FACILITY: Midland Plant, Units 1 and 2

SUBJECT: SUMMARY OF JANUARY 13, 1982 MEETING ON BORATED WATER STORAGE TANKS

Subject: Midland Project, Corps of Engineers review comments on Design Report for the Borated Water Storage Tank Foundations, Report Transmitted November 13, 1981 in letter from J. Cook to H. Denton.

CIVIL/STRUCTURAL QUESTIONS ON BWST

FIGURE 1-3. COMPARISON OF TANK 1T-60 RING WALL RELATIVE ELEVATIONS BEFORE AND AFTER THE GROUND SETTLEMENT

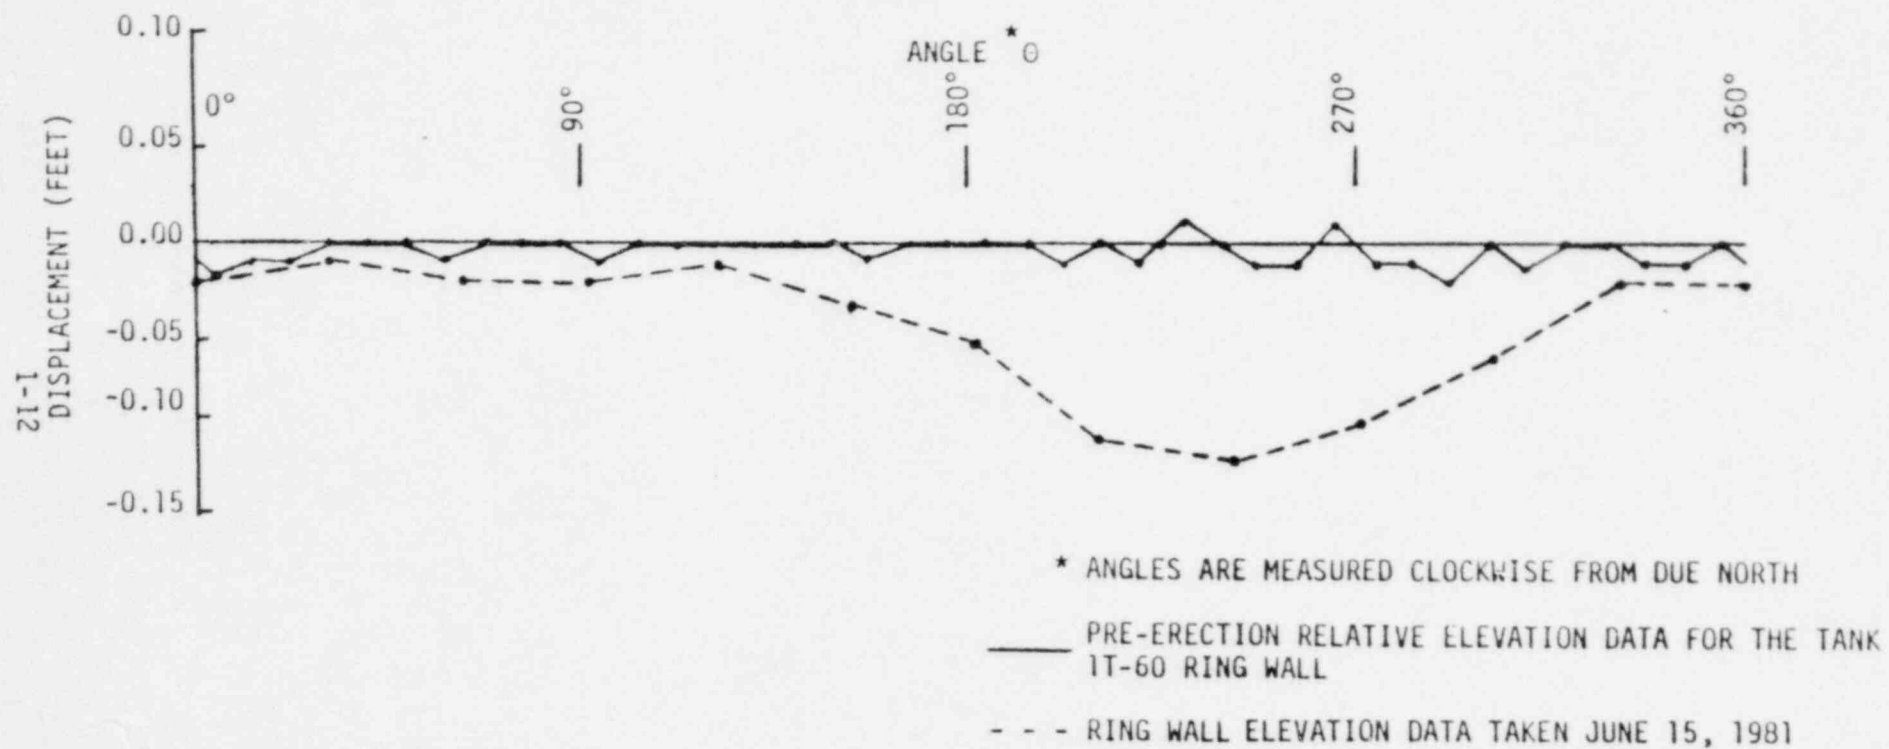
SOIL SETTLEMENT HAS RESULTED IN DISTORTION OF  
RING WALL TOP SURFACE

SUPPORT OF BWST WALLS IS NON-UNIFORM

ANCHOR BOLT LOADING IS NON-UNIFORM
